415 LEGGET DRIVE STORMWATER MANAGEMENT REPORT

6TH SUBMISSION

Subject: Site Plan Control Application – 415 Legget Drive and 2700 Solandt Road – 4th Review Comments

Figure 2: 3-hour Chicago Design Storm Hyetographs - Ottawa

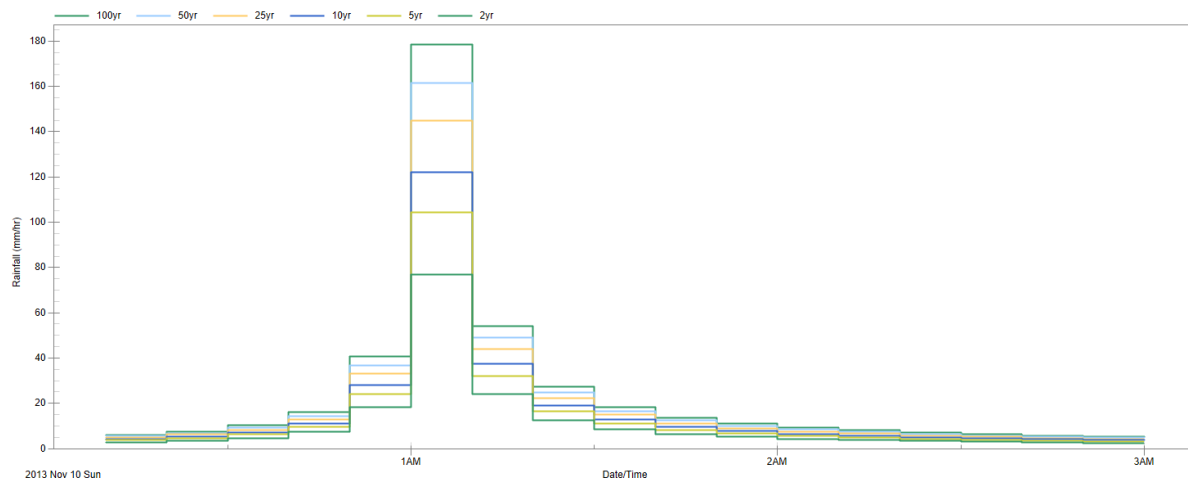
- 1.10. Initial Comment: Please provide tables all the rainfall hyetographs used.

Developer Response: The 3-hour Chicago design storm was used for each return period event. Hyetographs have been added to the report.

Figure 4: Proposed pond outlet structure

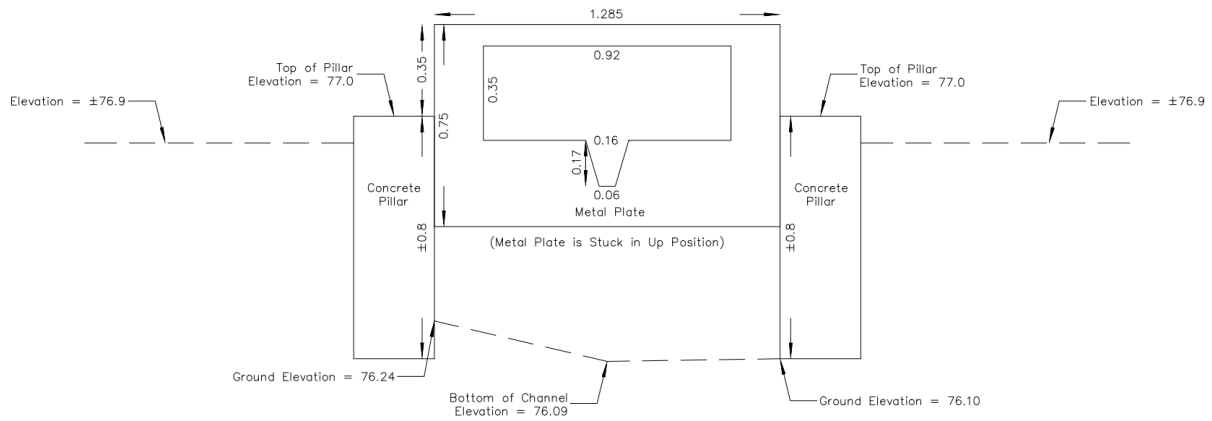
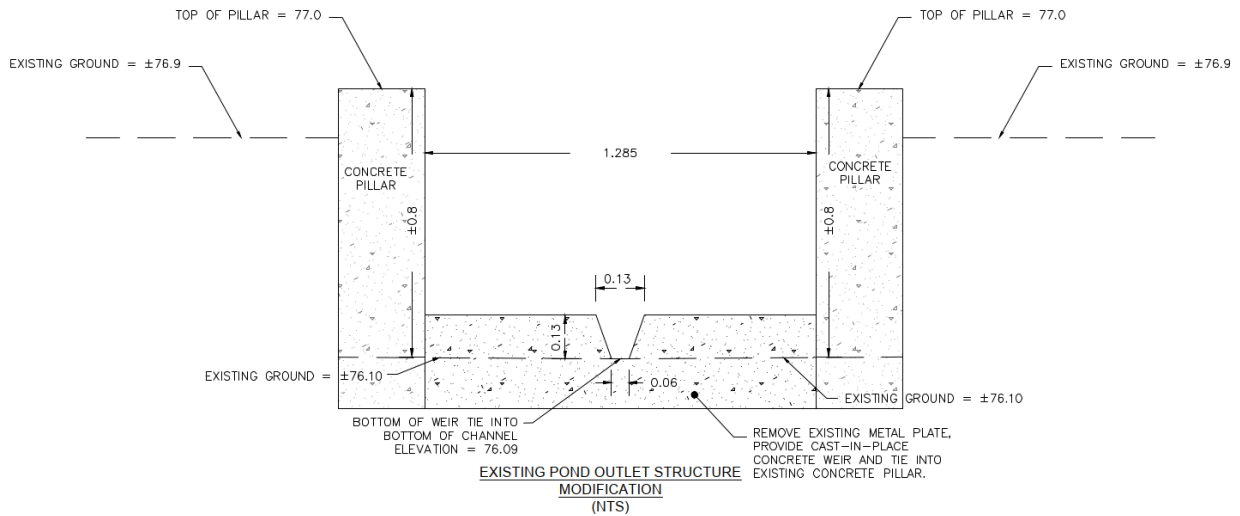
It would be helpful if table 7 also included the outflows. Please provide information on how the proposed v notch weir set at the channel bottom is modeled in PCSWMM. The invert of the weir is set at the channel bottom, and this will not be free flowing. With this new proposal to lower the outlet please provide information on the downstream channel and its possible effect on the outflow from the pond. There should be a channel segment added downstream of the pond outlet structure.

The change in the outlet will be include in the amendment to the ECA.
